NOTICE OF PROPOSED CHANGE IN PROPERTY

Petition: x1772

RE: Request for encroachment into Shelby Street.

REQUEST ENCROACHMENT  
 INTO GRISWOLD  
 AT 1249 GRISWOLD

<b>CITY OF DETROIT</b>	
CITY ENGINEERING DEPARTMENT	
SURVEY BUREAU	
<b>JOB NO.</b>	01-01
<b>DRWG. NO.</b>	X 1772

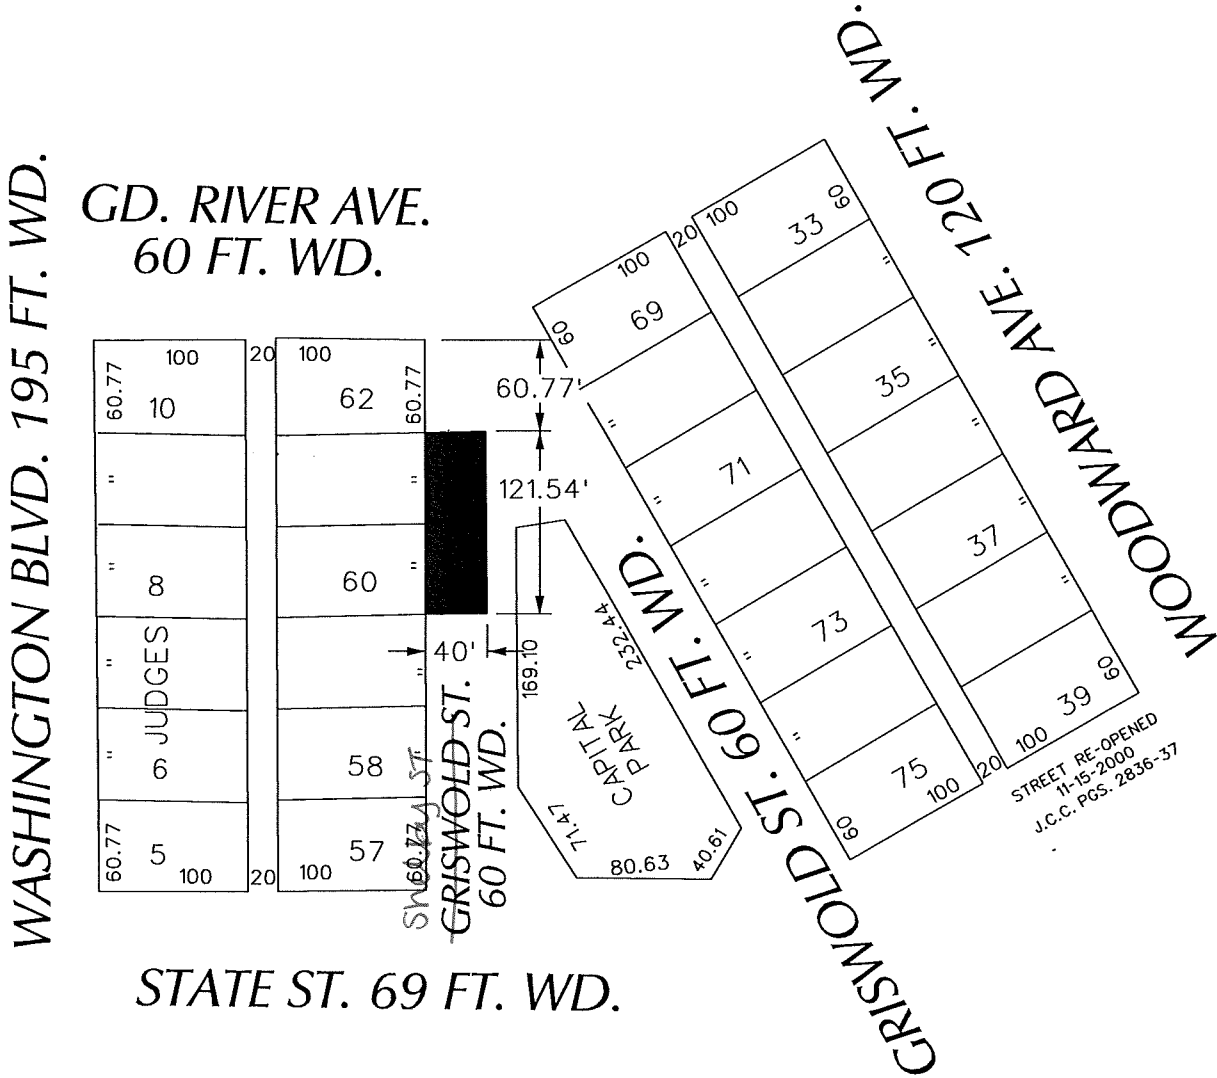
- Not Involved
- Involved; but asking you to hold action on this petition until further notice.
- Involved; but no objections to the property change.
- Involved; objection to the property change.
- Involved; but no objections to the property change...provided as easement of the full width of the public right-of-way (street, alley or other public place) is reserved.
- Involved; the nature of our services and the estimated costs of removing and/or rerouting such services are:

DTE Energy  
(Utility or City Department)
